NOTICE OF A TYPE II DECISION ON A PROPOSAL IN YOUR NEIGHBORHOOD

CASE FILE NUMBER: LU 08-145989 DZ - DESIGN REVIEW FOR CANOPY, LIGHTS AND STOREFRONT ALTERATIONS

Site Address: 1009 SW 6TH AVENUE

The applicant seeks Design Review for new glass awnings and lighting along the east façade of the Sixth Avenue Garage. The proposal includes removal of the continuous barrel vaulted awning that extends along the entire east elevation. Portions of the tube-steel support structure will remain, be refurbished, and incorporated in the new awning design. The center of the frame in front of the garage entrance will be removed and the ends would be flush finished. The new awning consists of new glass canopies on portion of the façade that coincide with ground level tenant entries and outdoor seating areas along SW 6th Avenue. LED lighting is also proposed to be concealed in the upper awning frame to wash the street level structural columns with light.

PROPOSED EXTERIOR ELEVATION
A3.1

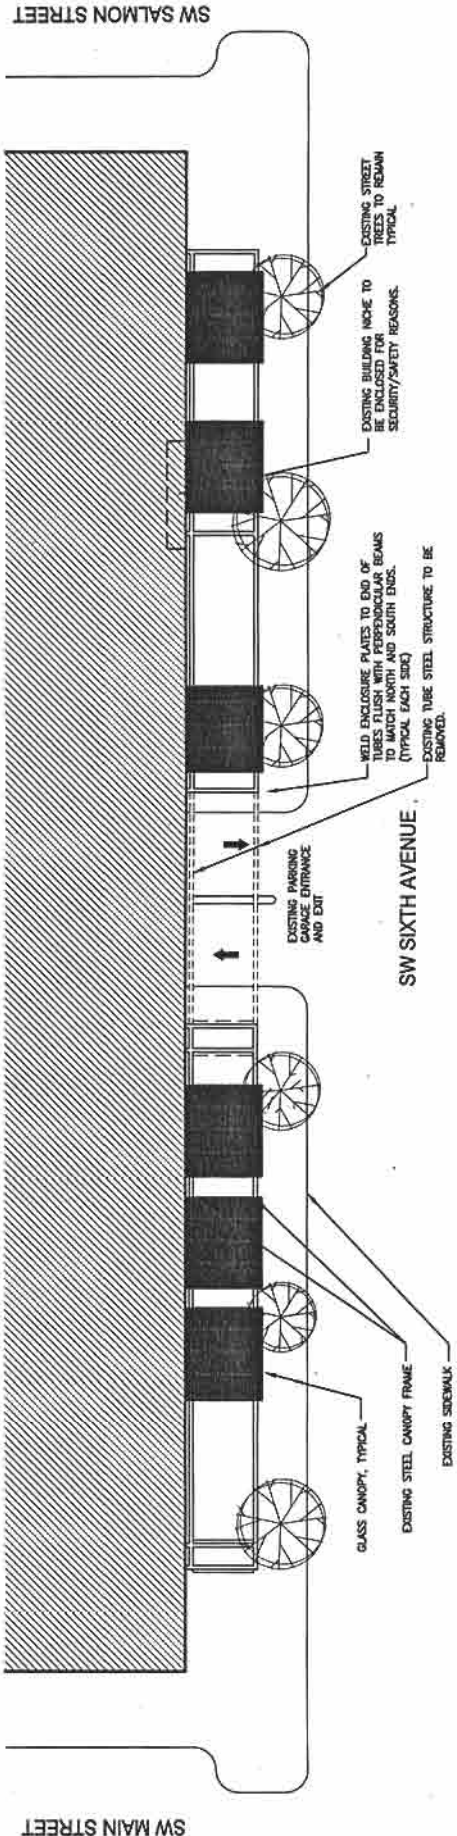
Findings: All elements of the proposal enhance and protect the pedestrian system. The LED lighting at the five columns along the ground level provides night illumination of the sidewalk for pedestrian safety and adds interest by highlighting the structural columns of the building. The new storefront screens the large ground level vent by enclosing it with a storefront and providing a vent in the upper transoms away from the pedestrian environment. The new glass canopies are located specifically at the pedestrian entrances and outdoor seating area to provide protection from the weather elements. The transparency of the glass allows natural light to meet the sidewalk unlike the previous less translucent awning creating a more pleasant and well lit environment. *These guidelines have been met.*

Findings: The LED light fixtures and all associated conduit will be concealed in the upper steel canopy frame. They will be directed towards the building's structural columns washing them with light and casting illumination down towards the sidewalk. This type of lighting and installation will highlight the structural columns along the base of the building, have no impacts on the nighttime skyline and provide for a safer, well-lit pedestrian environment. *This guideline is therefore met.*

ENLARGED PARTIAL SITE PLAN
A2.0

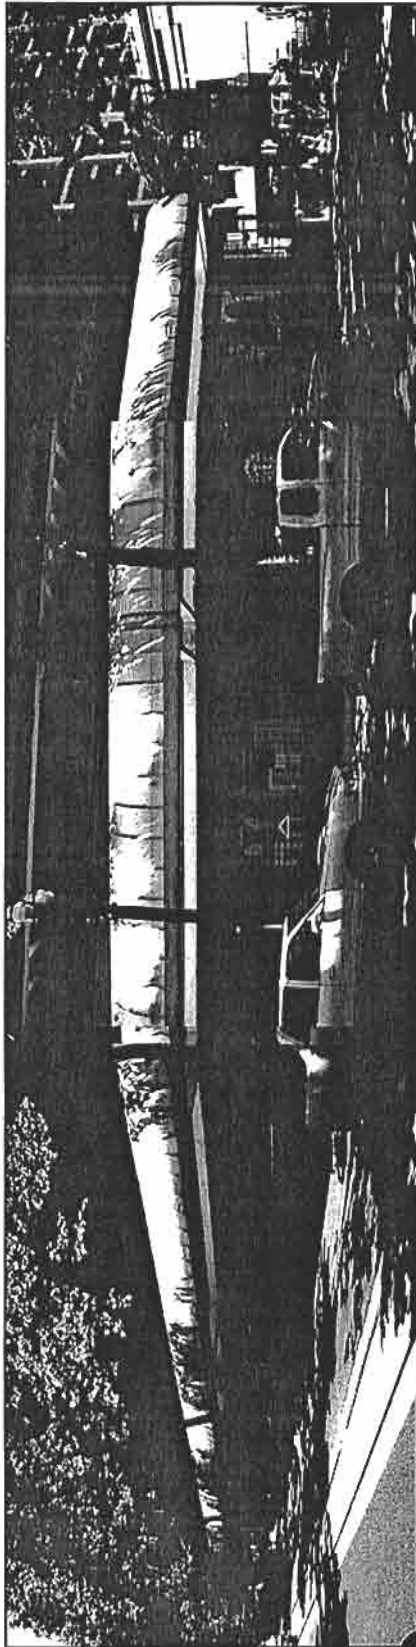
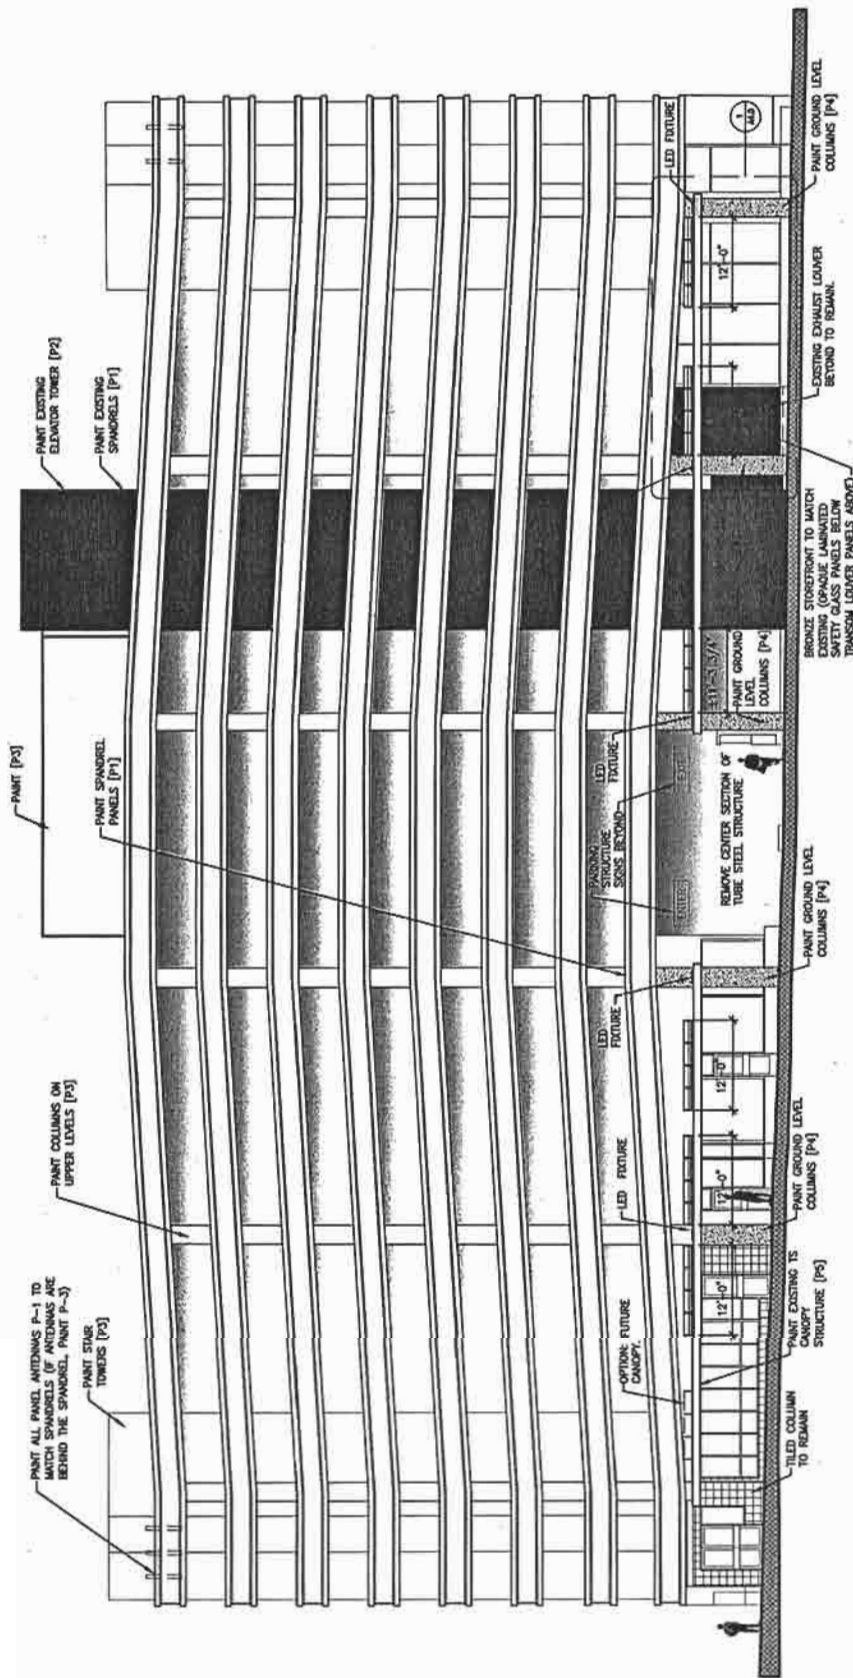
Findings: The proposed canopy alterations will utilize the steel frame of the existing awning. The fabric barrel awning will be removed as will portions of the steel frame in front of the garage entrance. The remaining steel frame will be painted and used to support the new glass canopies above the storefronts and pedestrian entrances. *This guideline is therefore met.*

Modifications to the 9'-0" deep steel frame include removing the center portion above the garage and welding an inset flush plate on the end of the beams for a seamless finish. The break in the frame aligns with the structural columns and center of the building which provides some relief from the continuous horizontality of this ramped garage. Limiting the frame to locations above the storefronts only helps to emphasize the non vehicle aspects of this parking garage. The new glass canopies will sit atop the steel frame and project 0'-11" beyond its edge into the right-of-way. The glass locations on the frame correspond to pedestrian and tenant entries as well as outdoor seating area resulting in a coherent ground level composition.

Findings: The steel tube awning frame is an existing encroachment in to the pedestrian walkway. Retaining the frame and adding new glass canopies continues to enhance the pedestrian environment by providing a shelter from the weather while the new transparent glass canopies are unobtrusive and allow light down to the sidewalk. The awning also continues to distinguish the ground, sidewalk level of the building from the upper floors. *These guidelines are therefore met.*
